STAFF BRIEF

Project: 2017-COA-311* **LPC Meeting:** November 5, 2019
Address: 160 W. Maple Ave **Staff:** Jennifer Cappeto
Historic Dist/DLM: Baker Neighborhood Historic District
Council District: #7 – Jolon Clark
Applicant: Tim Peters, Peters Construction

Description: Garage demolition and ADU construction

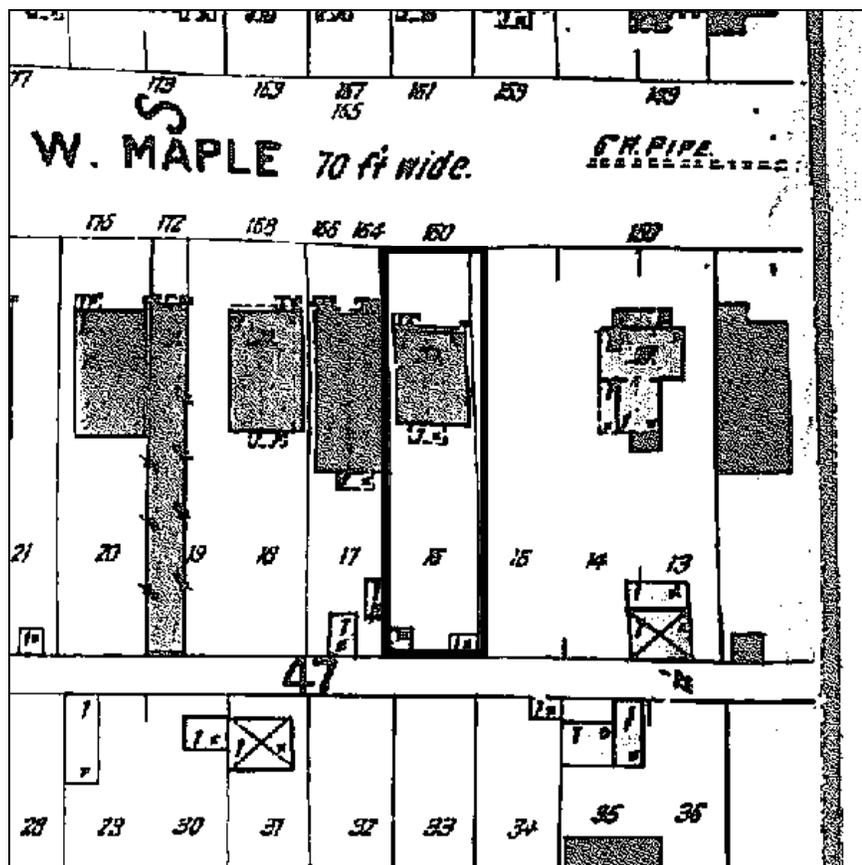
Guideline	Meets Guideline?	Comments
4.6 Use materials that appear similar in scale, color, texture and finish to those seen historically in the district.	No	The siding used was LP Textured Hardboard, an engineered siding material according to the

<p>c. New materials that convey characteristics similar to historic materials may be considered if they have a similar appearance, size and shape to traditional materials. Such materials may include smooth-finish (non-wood grain) fiber cement board and cast stone, when they are detailed to convey a sense of authenticity.</p> <p>f. Do not use fiber cement board that is detailed to resemble wood grain.</p>		<p>product's website. It has a faux wood-grain texture and was installed with a 4" exposure.</p>
---	--	--

Recommendation: Denial

Basis: The use of faux wood-grain siding does not meet guideline 4.6c or 4.6f.
